STATE OF NORTH CAROLINA
DEPARTMENT OF TRANSPORTATION

Subject: DCM Consistency for the proposed US 70 Havelock Bypass in Craven County. TIP No. R-1015. WBS 34360.1.2.

The purpose of this letter and information package is to provide information on modifications to our plans for the Havelock Bypass, now under construction. These changes may require a revision to the Division of Coastal Management's CAMA Consistency Determination for the project. This package includes supplemental information in this letter, revised permit drawings and a revised Division of Mitigation Services acceptance letter.

Splice Pits Hand Clearing Impacts =
 10.0' x 10.0' (100.0 Sf) x 4 Splice Pits = 400 SF
 HandHold Pit Hand Clearing Impacts =
 5.0' x 3.0' (15.0 SF) x 1 HandHold Pit = 15 SF
TOTAL For This Sheet = 415 SF

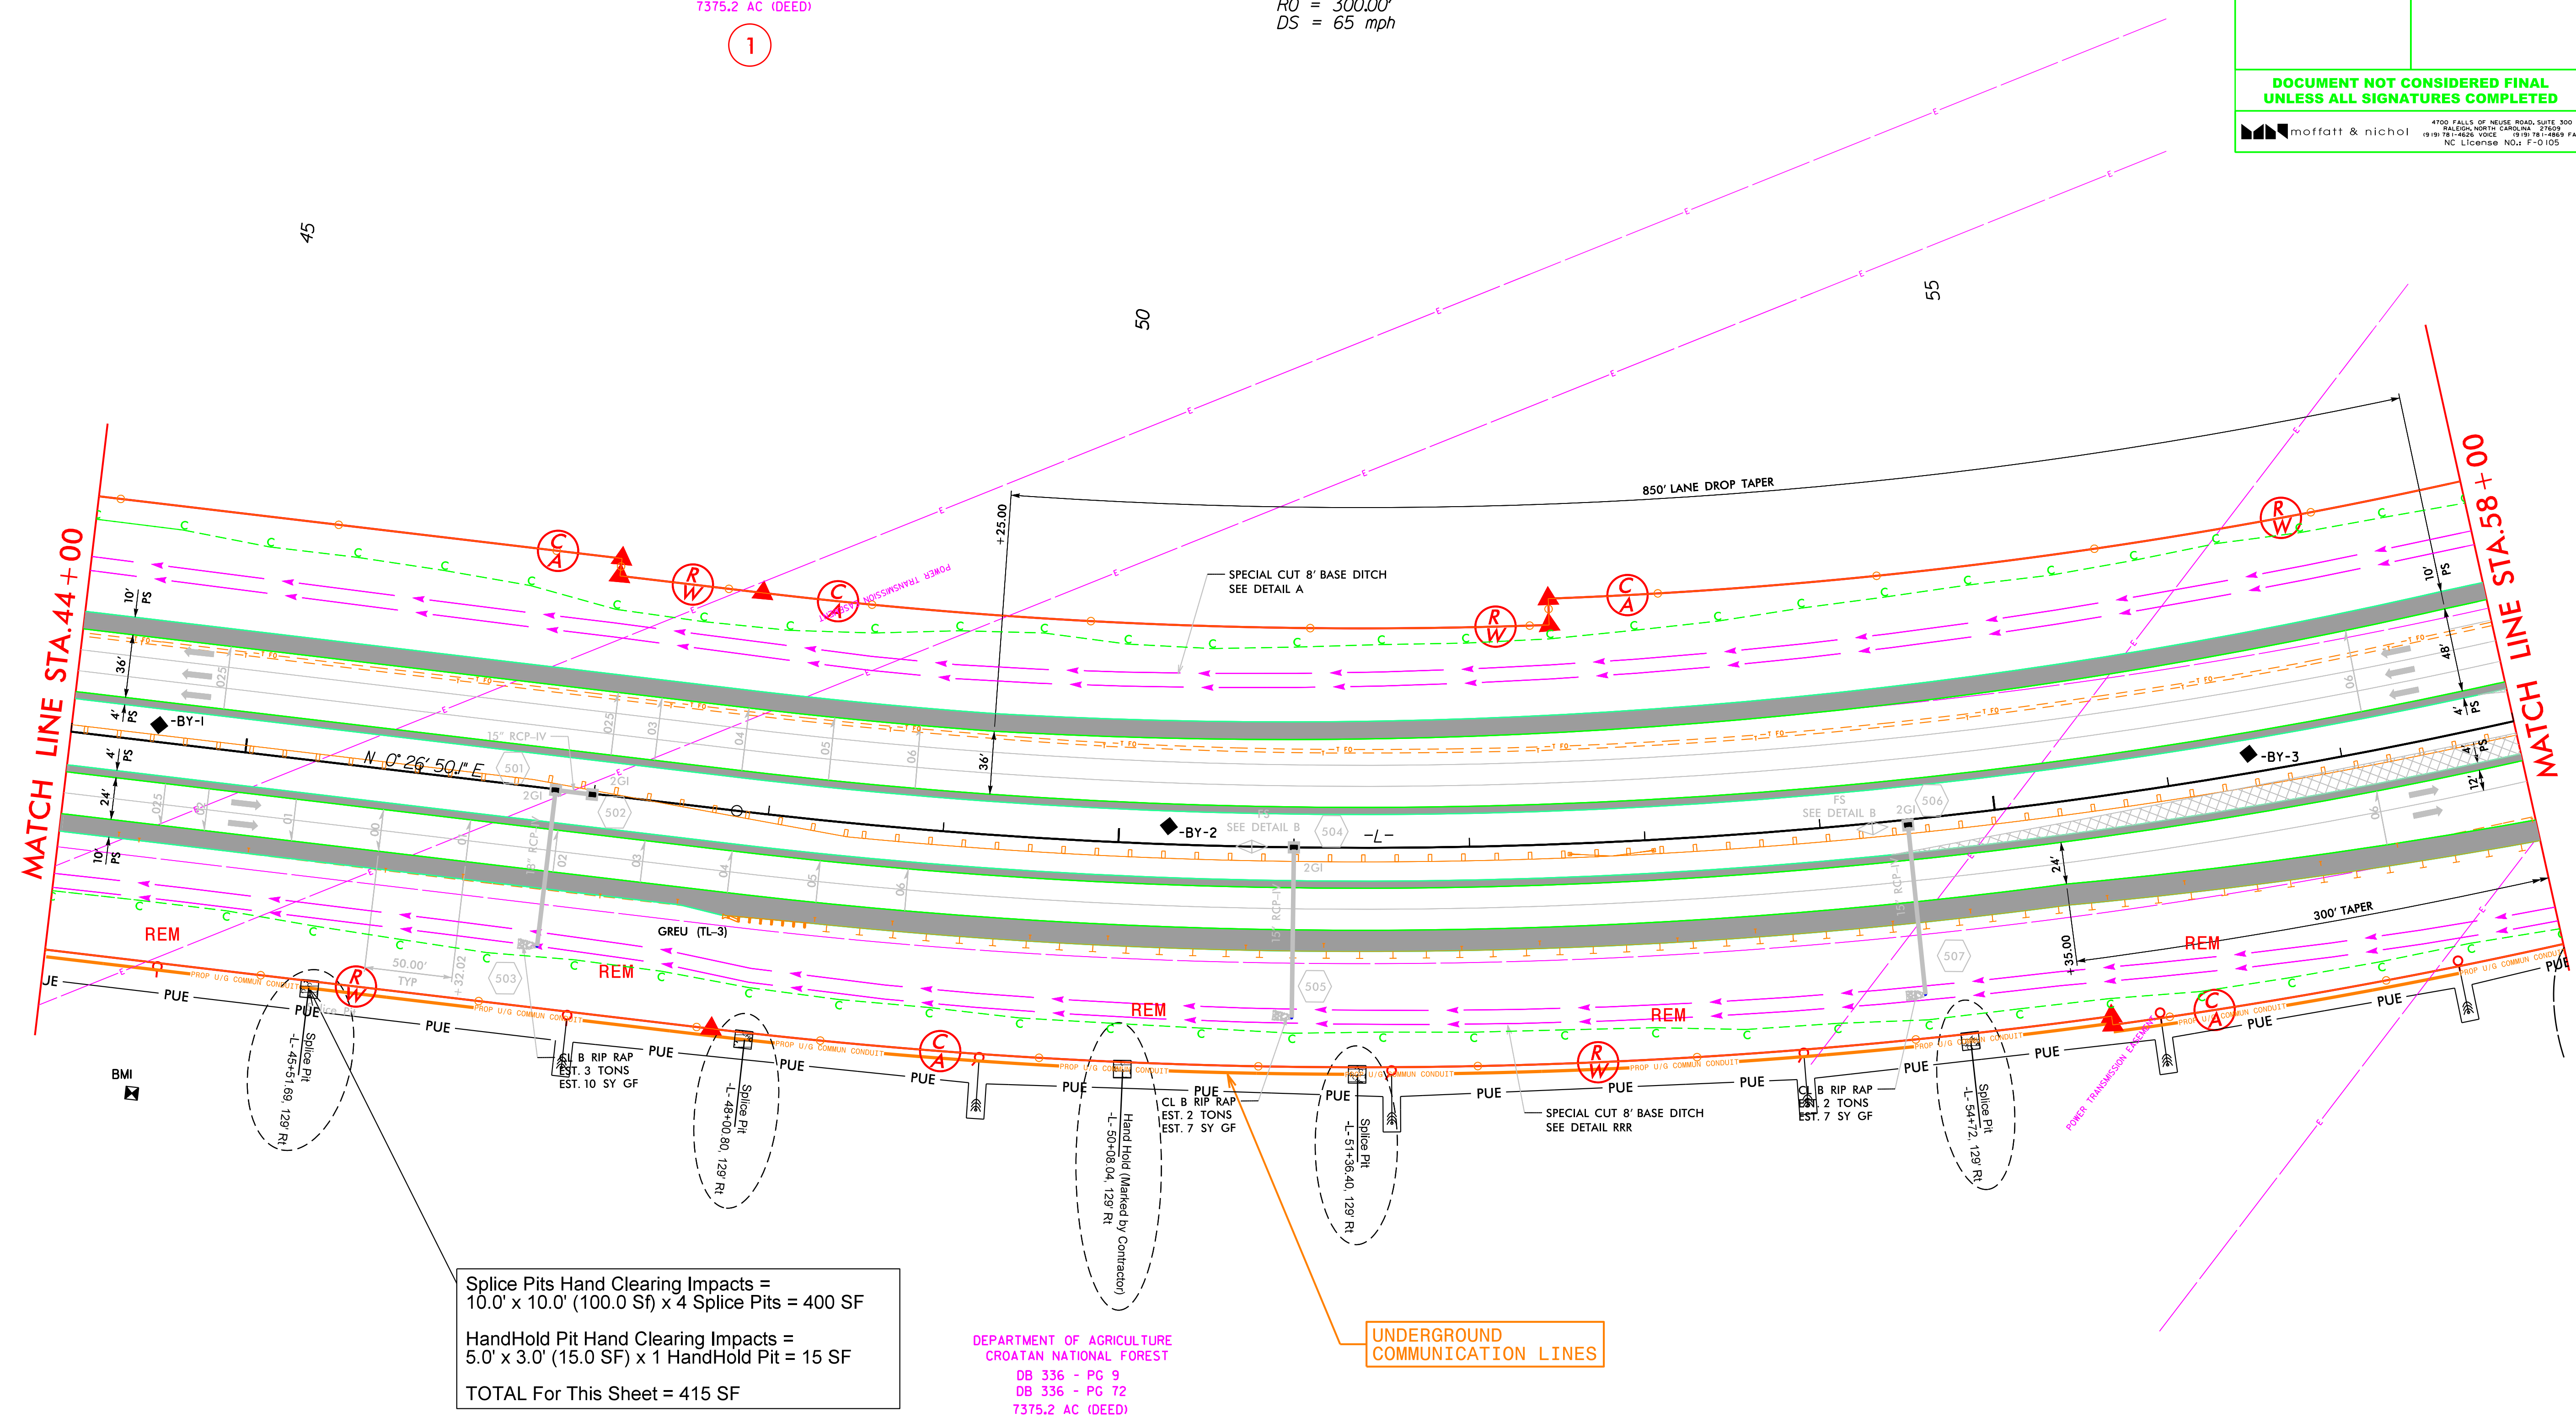
- Additional sheets have been prepared for the underground utility which requires additional impacts in wetland Sites 1, 2 and 3. The permit drawings showed underground utilities through these sections, but with no splice pits or hand holes, which are required. These supplemental drawings were revised by Division 2 to show the permanent hand holes and temporary splice pits with the total impacts required. These totals are not included in the summary sheet prepared by Hydraulics Unit. Impacts shown on the supplemental permit drawings are as follows:
 - = NE-03, 400 s.f. for splice pits and 15 s.f. for hand holes
 - = NE-04, 500 s.f. for splice pits and 30 s.f. for hand holes
 - = NE-05, 600 s.f. for splice pits and 30 s.f. for hand holes
 - = Additional total impacts needed = 1,575 s.f. (0.036 acre) of handclearing for bore holes.

BUFFER DRAWING SHEET 13 OF 20

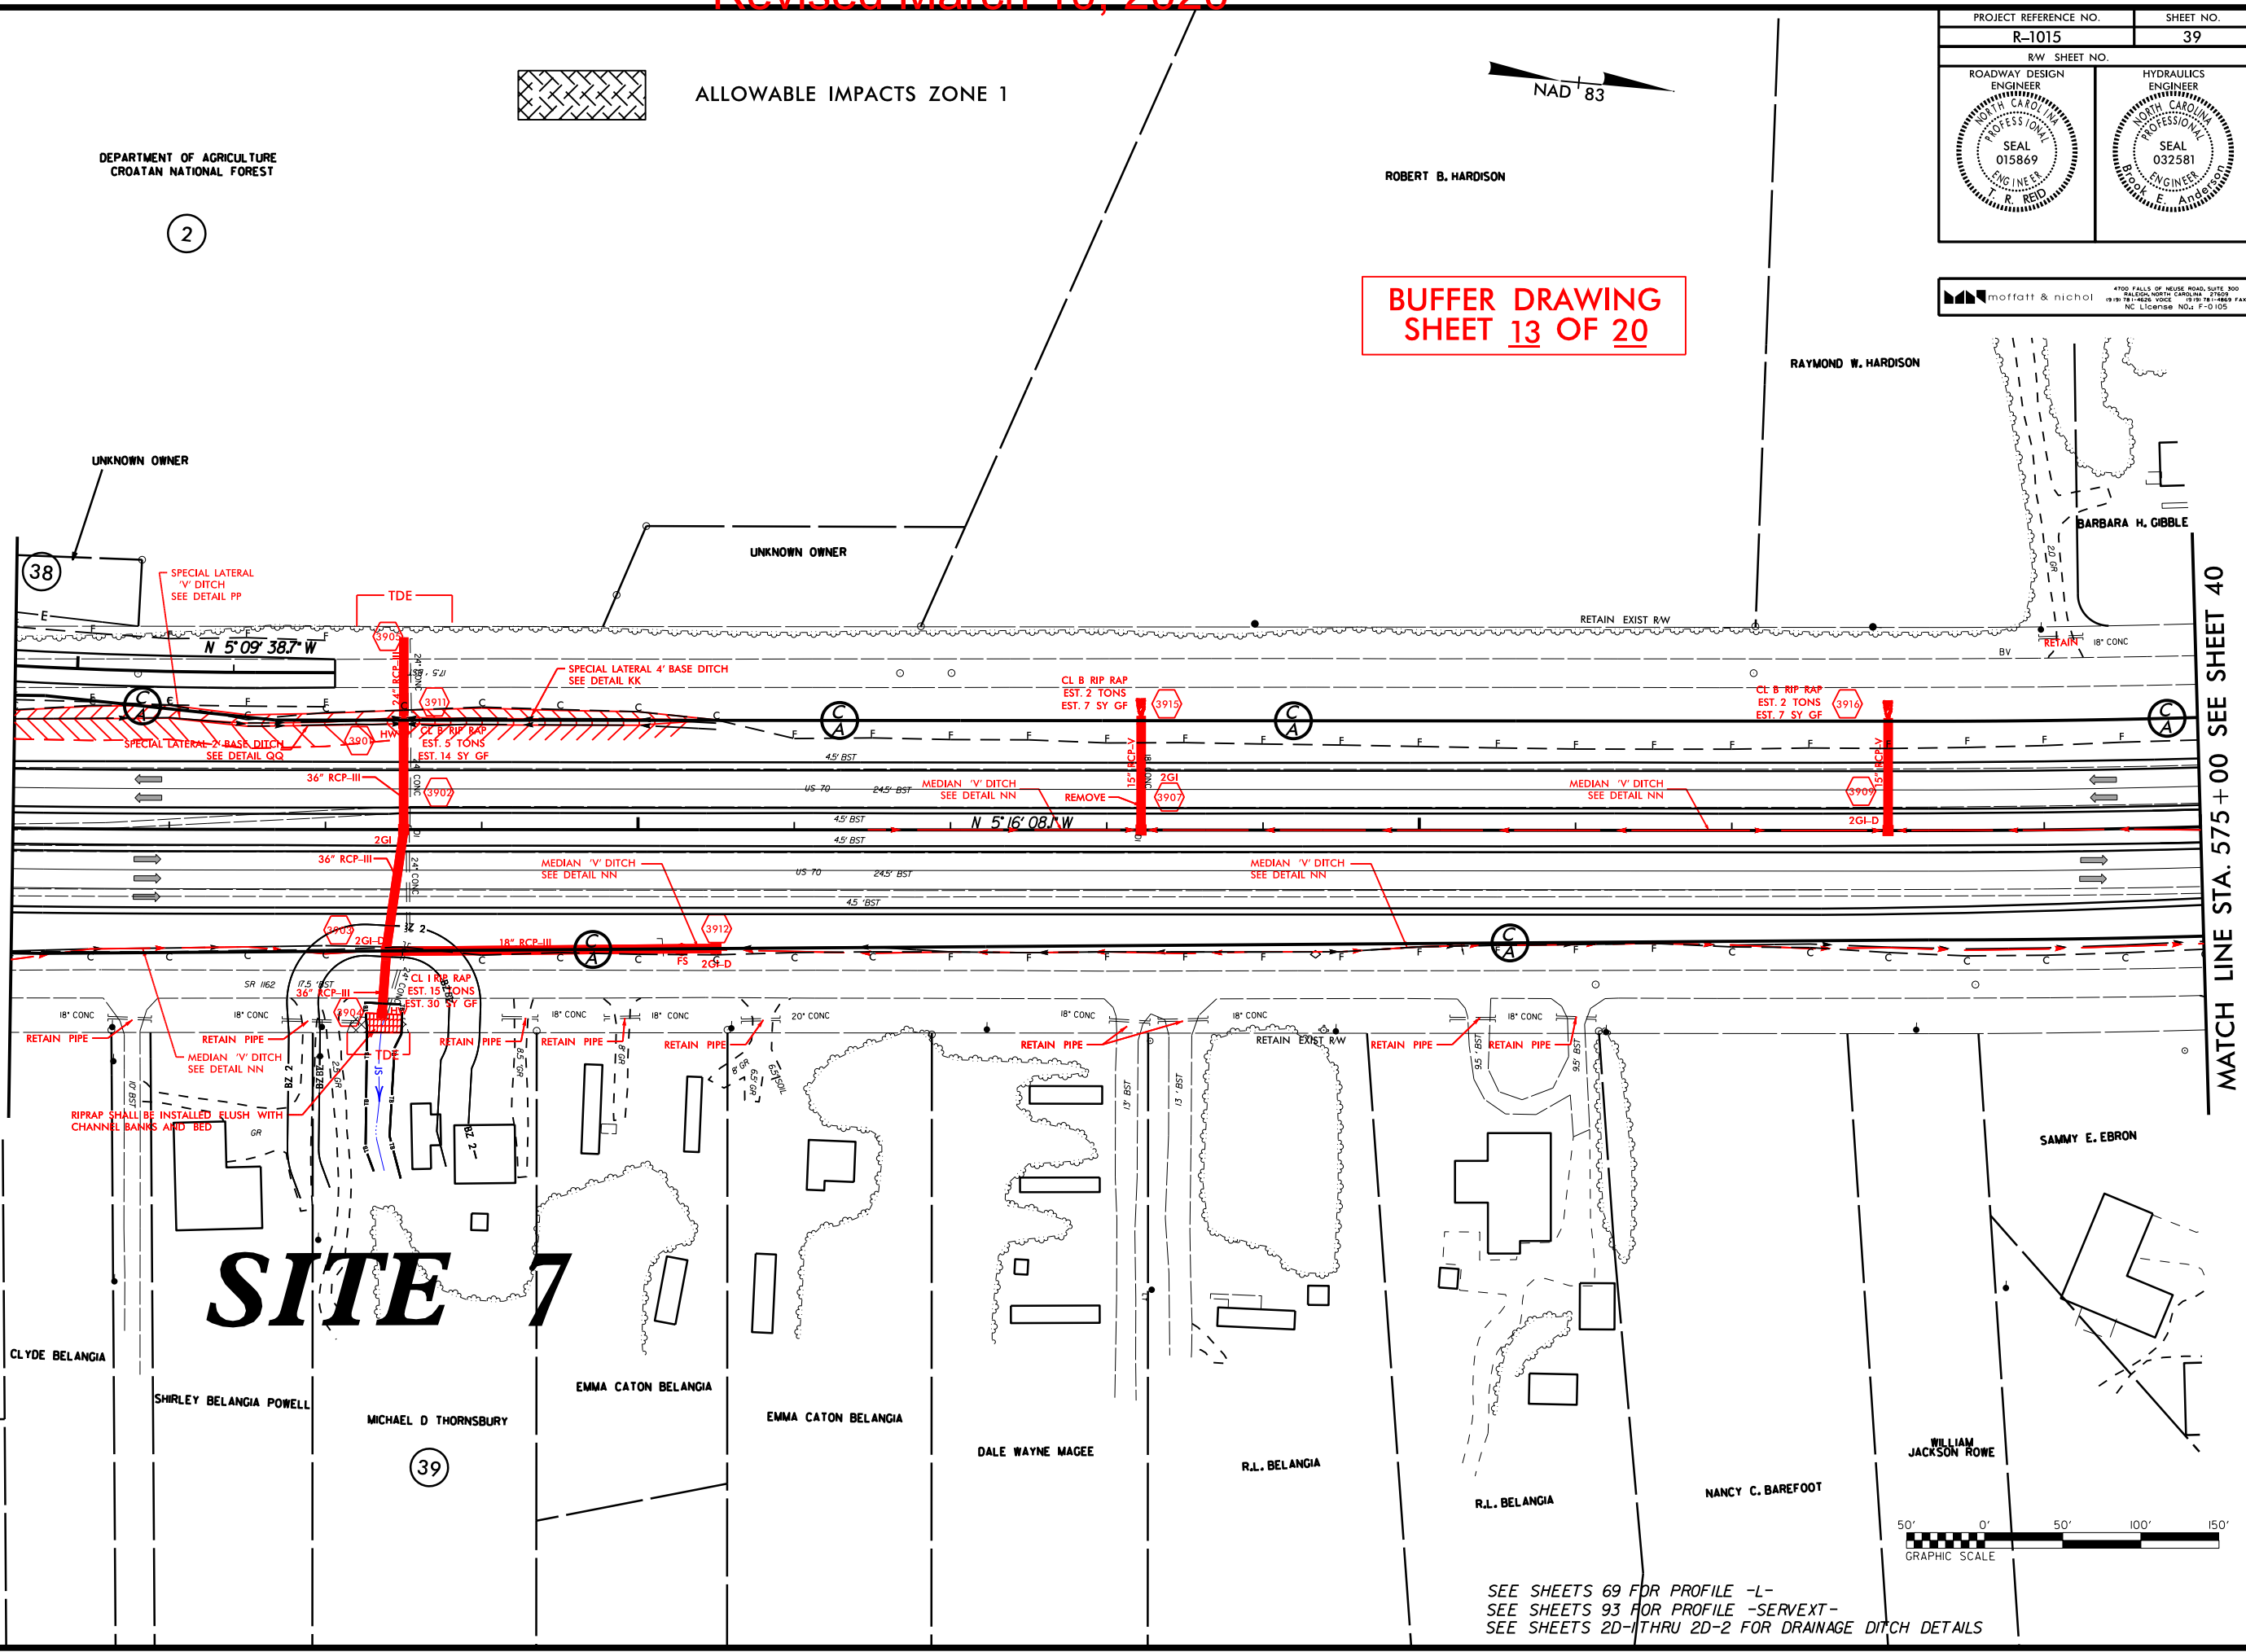
- Site 7 (buffer sheet 13) reduced Allowable Zone 1 impacts by 281 s.f. The pipe was shortened to eliminate easement on property, and a headwall added.
- Summary updated (buffer sheet 18 & 19). Allowable Zone 1 impacts are reduced from 42,810 s.f. to 42,529 s.f. due to the changes at Site 7.
